IEE802.3 4P Task Force

Updating 33.3.7.10 per D1.5 requirements

January 2016

Rev7

Figure 33-18a – PD PI pair-to-pair test circuit

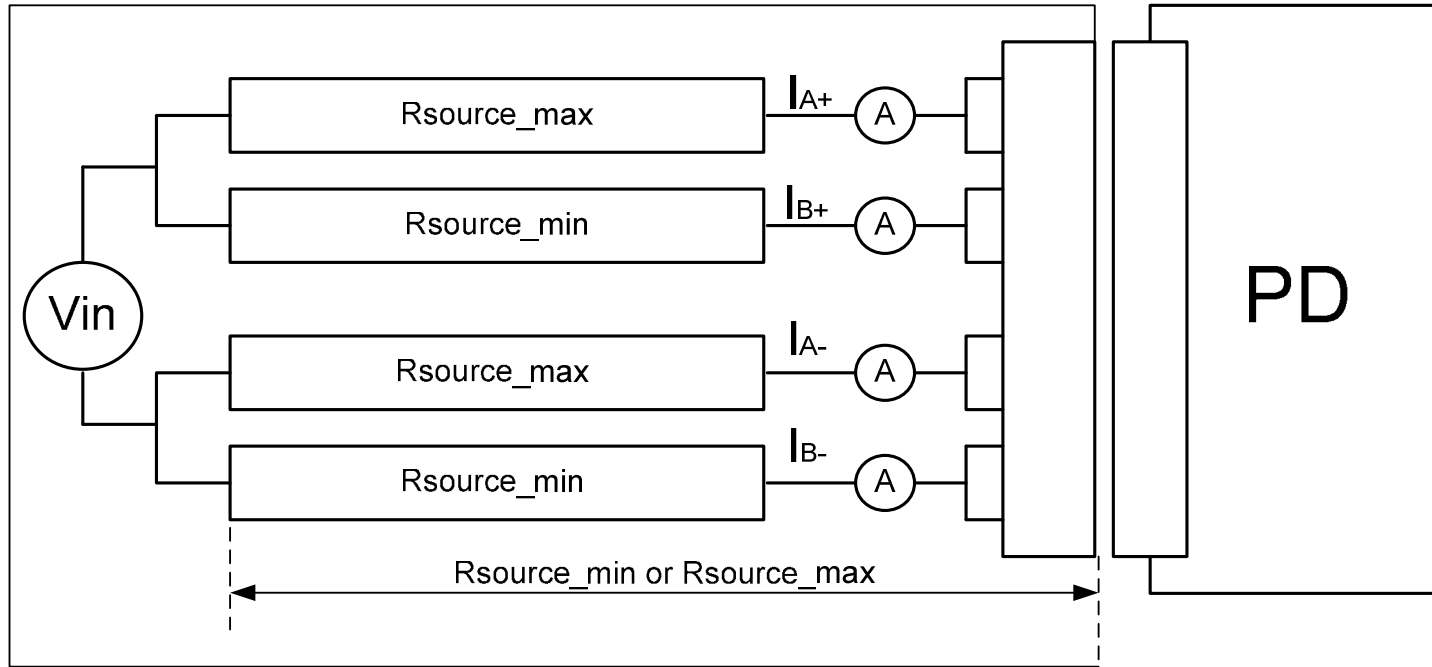
4. It was noted also that the test circuit doesn’t address the fact that R_{source} min/max are very low resistance and it is not clear if the connectors are part of R_{source} and if it is, the connectors may affect very much the total value of R_{source} etc. To fix this problem the following changes were made:

- a) The drawing of the test circuit was modified to show clear boundaries of R_{source} min/max
 - b) The effect of the test circuit connector resistance on R_{source} is minimized by specifying max connector resistance (plug of the test circuit, it is practical to use in test circuit side high quality connector) and subtracting it from R_{source} . In addition we increase the R_{source} ABS numbers by 5% and allow 5% variations with negligible effect on current measurements. The PD RJ45 Jack is not part of the test circuit.

2. Update Figure 33-18a below:

1. R_{source} includes test setup plug resistance R_{con} . The maximum recommended R_{con} value is 0.02Ω however it is test setup implementation specific choice how to meet R_{source_min} and R_{source_max} .
2. The test needs to be conducted when in one test the two pairs of the same polarity contain R_{source_min} and R_{source_max} and in the 2nd test it flips values.
